SUBJECT:
LED SIGN BACKLIGHT

TECHNICAL BULLETIN: 17-09

OPTIONAL UPGRADE: LED SIGN BACKLIGHT

06100-00144 shown above

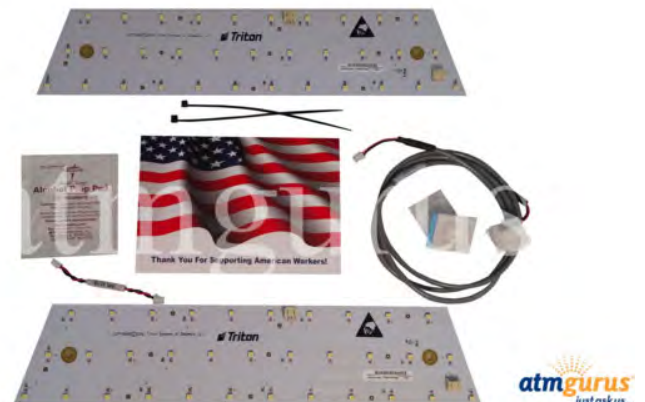
Triton announces a new, improved lighting solution to replace the LED sign lighting used in current products. Beginning immediately, all new and refurbished units will ship with the new, trapezoidal LED sign light. Kits will be available for field replacements via www.atmgurus.com or by calling Customer Service at 1 (228) 575-3100, option 3.
